Title - Sujet Const. (Phase 2)-Green Gables, PEI	
Solicitation No. - N° de l'invitation ED001-181274/A	Amendment No. - N° modif. 005
Client Reference No. - N° de référence du client R.081199.001	Date 2017-10-12
GETS Reference No. - N° de référence de SEAG PW-SPWC-024-4190	
File No. - N° de dossier PWC-7-40074 (024)	CCC No./N° CCC - FMS No./N° VME
Solicitation Closes - L'invitation prend fin at - à 02:00 PM on - le 2017-10-18	Time Zone Fuseau horaire Atlantic Daylight Saving Time ADT
F.O.B. - F.A.B. Plant-Usine: <input type="checkbox"/> Destination: <input checked="" type="checkbox"/> Other-Autre: <input type="checkbox"/>	
Address Enquiries to: - Adresser toutes questions à: Bysterveldt (PWC), Crystal	Buyer Id - Id de l'acheteur pwc024
Telephone No. - N° de téléphone (902) 940-7122 ()	FAX No. - N° de FAX (902) 566-7514
Destination - of Goods, Services, and Construction: Destination - des biens, services et construction:

THIS ADDENDUM IS RAISED TO PROVIDE THE FOLLOWING ANSWERS TO QUESTIONS PROVIDED BY BIDDERS.

THE FOLLOWING CHANGES IN THE TENDER DOCUMENTS ARE EFFECTIVE IMMEDIATELY. THIS ADDENDUM WILL FORM PART OF THE CONTRACT DOCUMENTS.

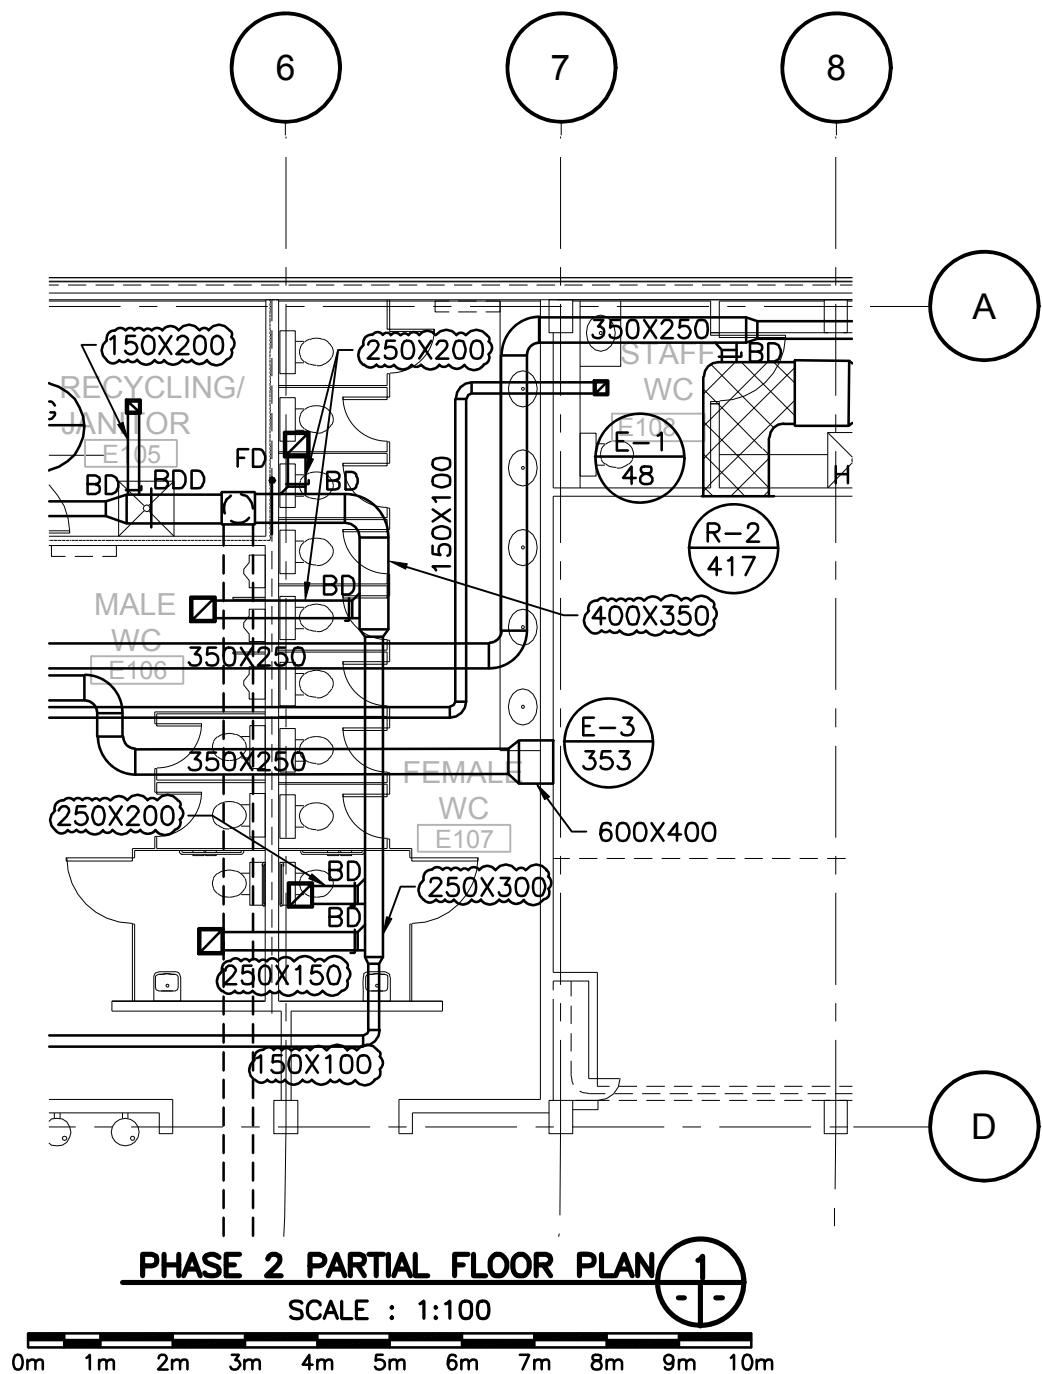
Mechanical: See new drawing MSK01 attached below.

1. Reference Drawing P02: Add ball valve to DCW pipe in corridor E120 at gridline L.
2. Reference Drawing P02: Add ball valve stop at P-8 to isolate water fountains.
3. Reference Drawing P02: Route 38mm DCW and 12mm DHW lines running through the Comm Rm E103 to the Hall E100.
4. Reference Drawing P03, detail 4: Mount trap primers at 1000 AFF.
5. Reference Drawing M01: exhaust ductwork above WR's and Janitor Room to sized as per sketch MSK-01.

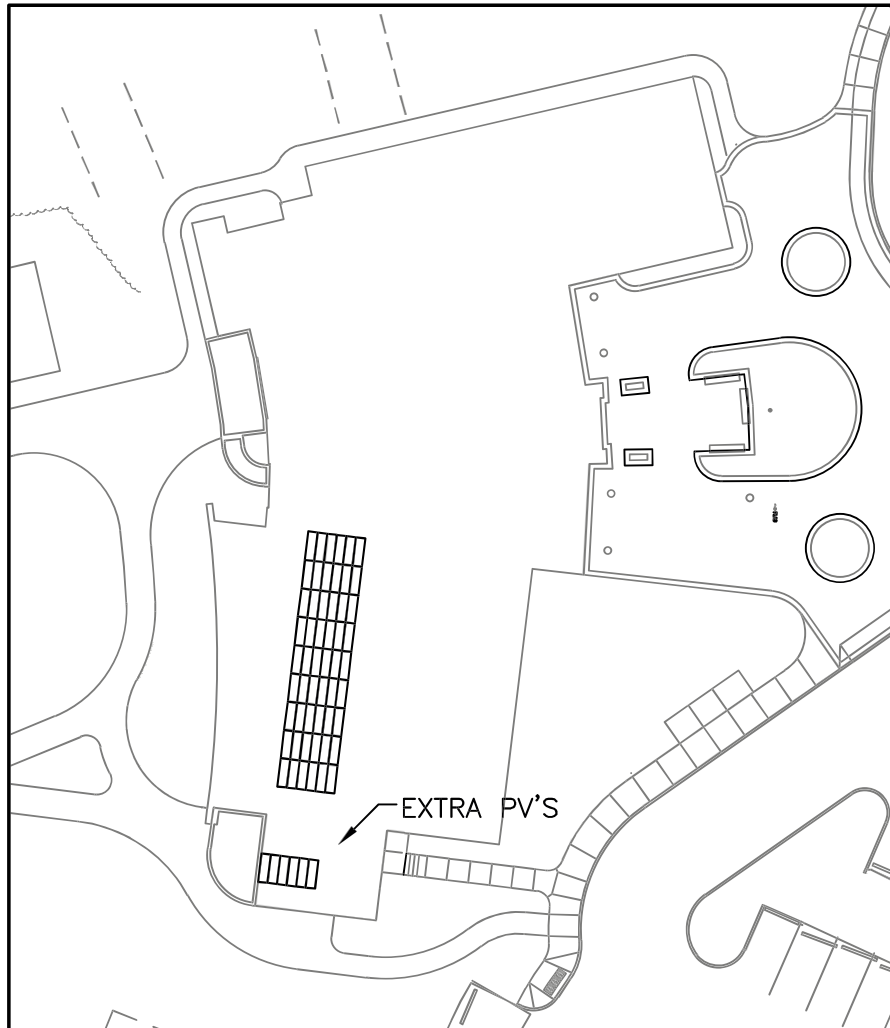
Reference Drawing ES01

1. Revise drawing per attached sketch ESK01.

drawing no.
ESK04

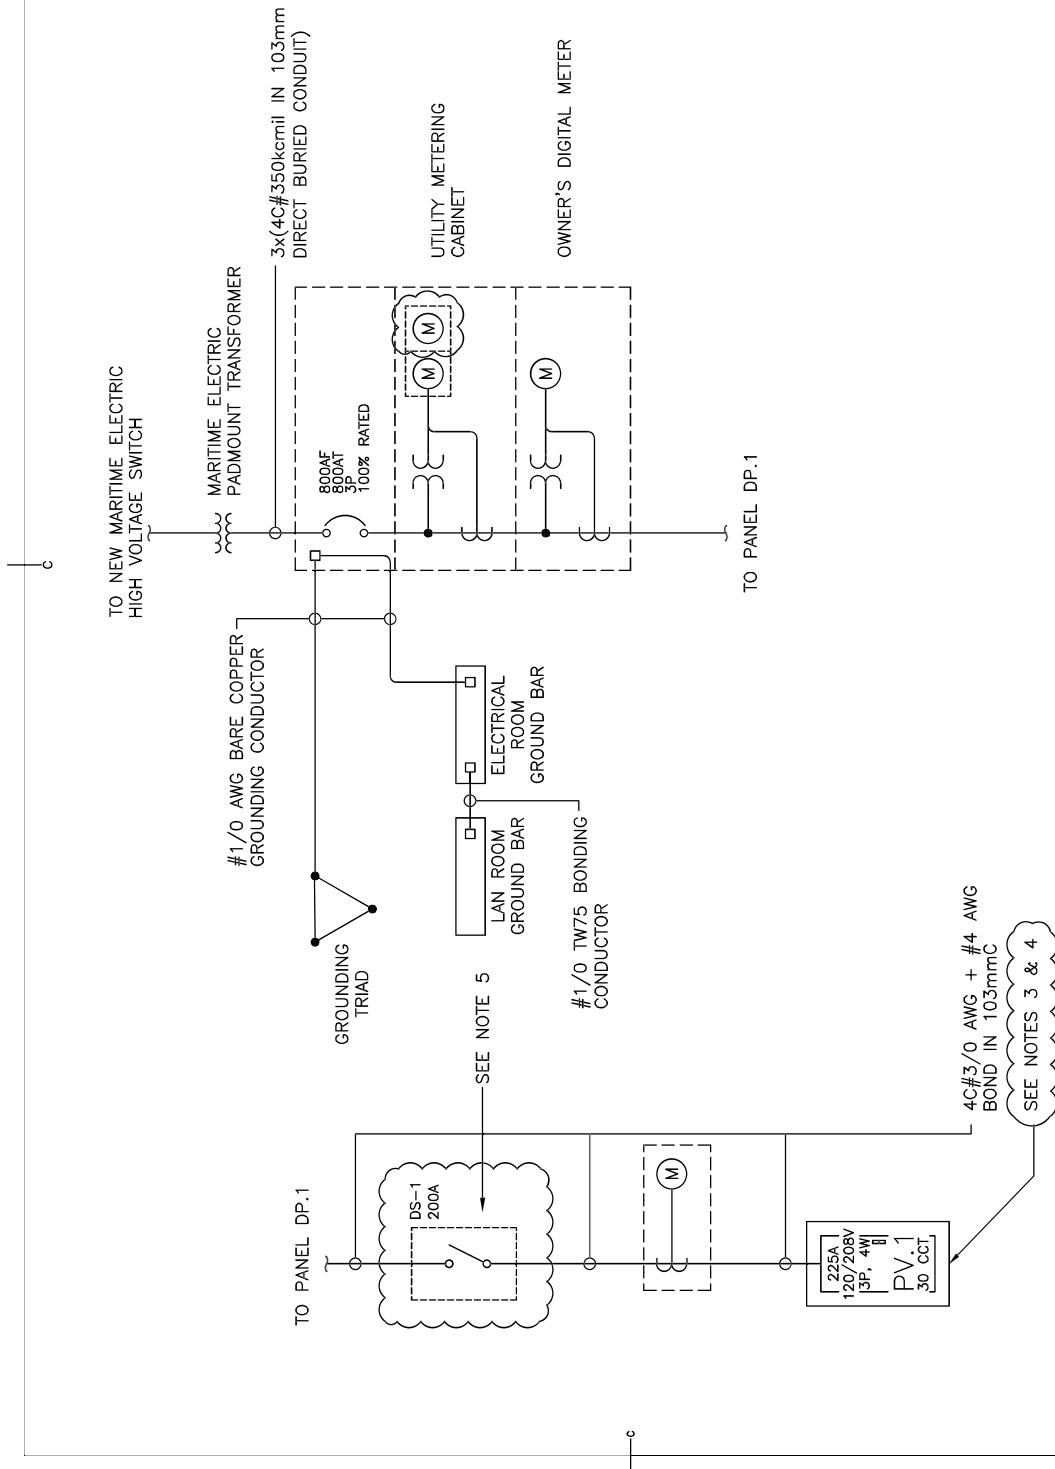
Reference Drawing EG07

1. Revise drawing per attached sketch ESK04

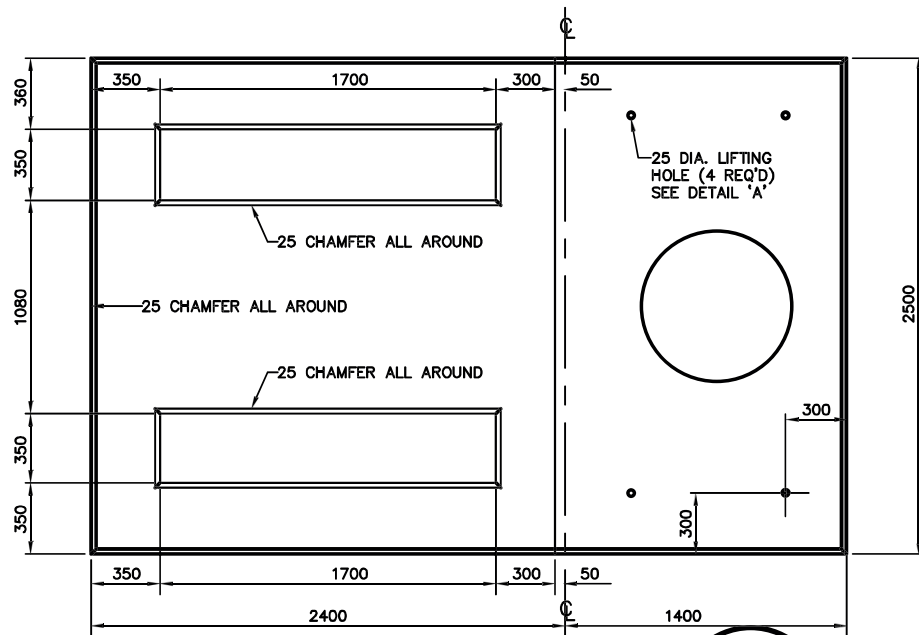
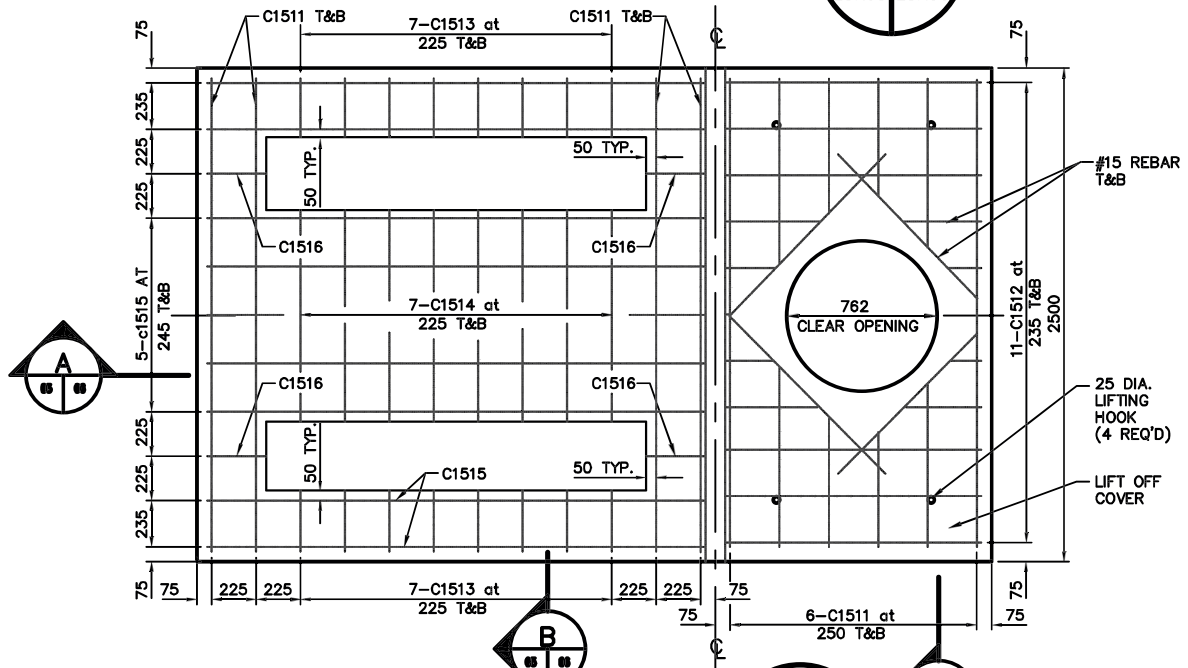
Reference Drawing EG02

1. Add Detail 7 per attached sketch ESK05.
2. Add Detail 8 per attached sketch ESK06.
